[Docket No. FAA-2012-0630; Directorate Identifier 2011-SW-010-AD; Amendment 39-17409; AD 2013-07-05]

Airworthiness Directives; Eurocopter France Helicopters

ACTION: Final rule.

SUMMARY: We are adopting a new airworthiness directive (AD) for Eurocopter France EC130B4 helicopters. This AD requires visually checking the center windscreen panel (center windscreen) for a crack and replacing the center windscreen if there is a crack, if the windscreen distorts during flight, or within 12 months. This AD was prompted by in-flight cracking and failure of a center windscreen. The actions of this AD are intended to detect a crack in the blending radii of the center windscreen to prevent failure of the windscreen, injury to the flight crew, and subsequent loss of control of the helicopter.

Figure 1 to Paragraph (e)(1)

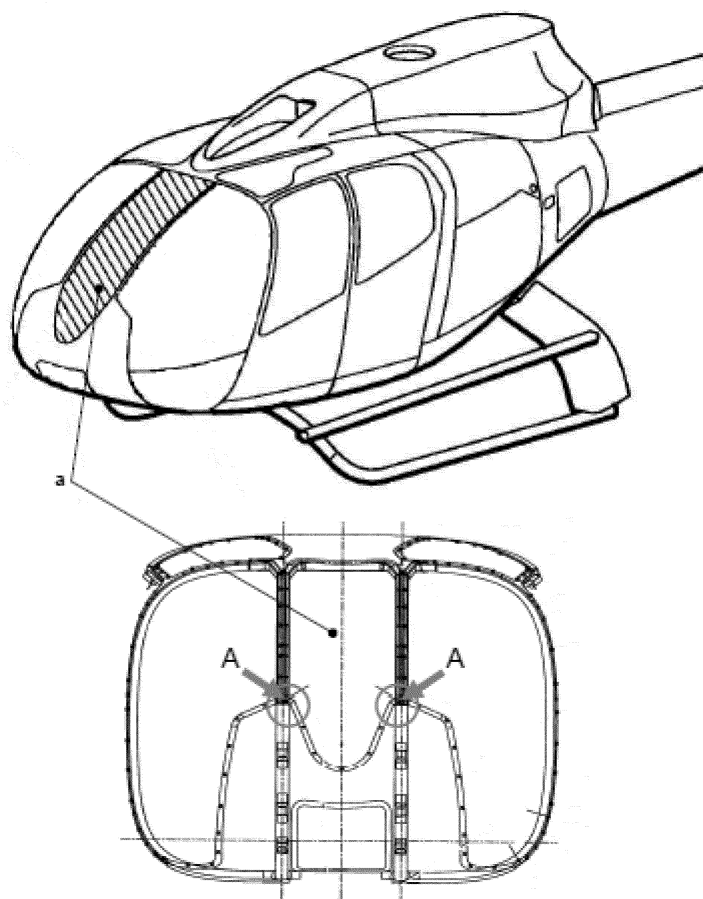
(1) Until the center windshield is replaced with center windshield P/N 350A25-9045-20, before each flight, visually check the center windshield for a crack in the area of the blending radii where the front-lower part of the center windshield joins the front fuselage as depicted in Figure 1 to paragraph (e)(1) of this AD. This visual check may be performed by the owner/operator (pilot) holding at least a private pilot certificate, and must be entered into the aircraft records showing compliance with this AD in accordance with Title 14 Code of Federal Regulations (14 CFR) 43.9 (a)(1)-(4) and 14 CFR 91.417(a)(2)(v). The record must be maintained as required by 14 CFR 91.417, 121.380, or 135.439.

(2) If there is a crack or if a pilot indicates that the center windscreen distorted during flight, before further flight, replace the center windscreen with an airworthy center windscreen, P/N 350A25-9045-20, in accordance with the Accomplishment Instructions, paragraphs 2.B.2.b. through 2.B.2.b.4., of Eurocopter Service Bulletin No. 56-003, Revision 0, dated November 16, 2010.

(3) Within 12 months, replace the center windscreen with an airworthy center windscreen, P/N 350A25-9045-20, in accordance with the instructions contained in paragraph (e)(2) of this AD.

(4) Replacing the center windscreen with center windscreen, P/N 350A25-9045-20, constitutes terminating action for the requirements of this AD.
